### REMARKS

Applicant : Patrizio Vinciarelli et al.  
Serial No. : 09/611,290  
Filed : July 6, 2000  
Page : 8 of 8

Attorney's Docket No.: 00614-092002

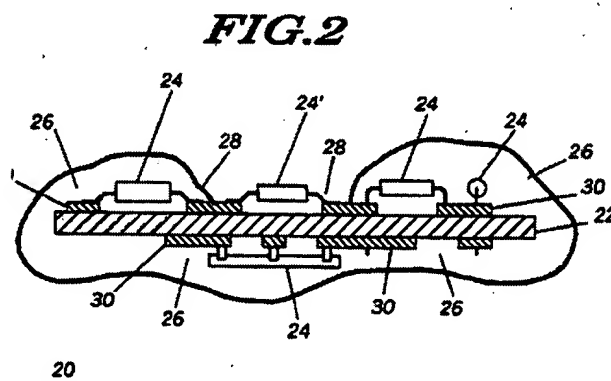
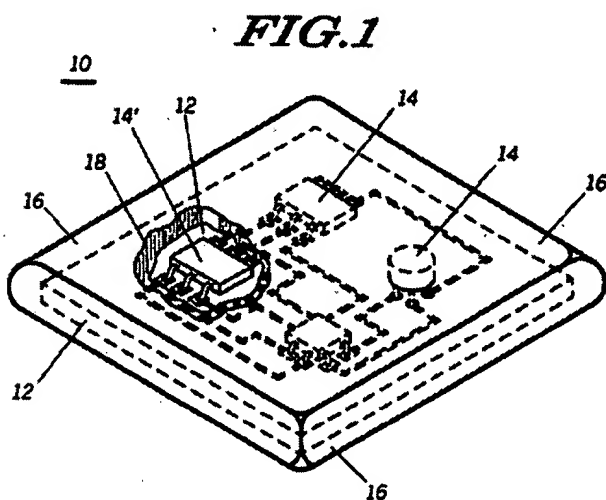
Regarding claims 30 and 39, Juskey et al. discloses an apparatus (electronic device 10, 20) as shown in figures 1-2 comprising:

- an electronic device (22), see column 4, lines 52-53, having an outer surface (the surface in which components 24 formed on) and a conductive termination (conductive traces 30), see column 4, line 55 (leads or pins of the components 24), on the outer surface;
- a protective, conformal coating (26), see column 4, line 56), on the surface of the electronic device (22); and
- a window (28), see column 4, line 64) formed in the protective coating (26) to expose a portion of conductive the termination (30 or the pins of the components 14),
- wherein the exposed portion of the conductive termination (a portion in which is not covered by the coating) is recessed in the window of the conformal coating (see top view of figure 1 and side view of figures 2).

Amended claim 30 requires, among other things, that the protective coating formed on the surface of an electronic device have a first window that exposes at least a portion of a first conductive termination without exposing any other conductive terminations on the device.

Juskey does not disclose or suggest such a device. As illustrated in its FIGS. 1 and 2, Juskey describes an electronic device 12/22 that is encapsulated in a conformal coating 16/28 having an single opening 18/28 that exposes multiple conductive terminations:

As clearly shown in these figures, the opening in Juskey does not expose a first conductive termination without exposing other conductive terminations of device 12/22 as required by claim 30. Moreover, claim 30 also requires that the window define a boundary for a solder connection between a terminal and an external circuit, which is also not disclosed or suggested in Juskey. Accordingly, Applicants submit that claim 30 is patentable for at these reasons. Claims 31-37 and 39-40 depend from claim 30, and, therefore, are patentable for at least the same reasons.
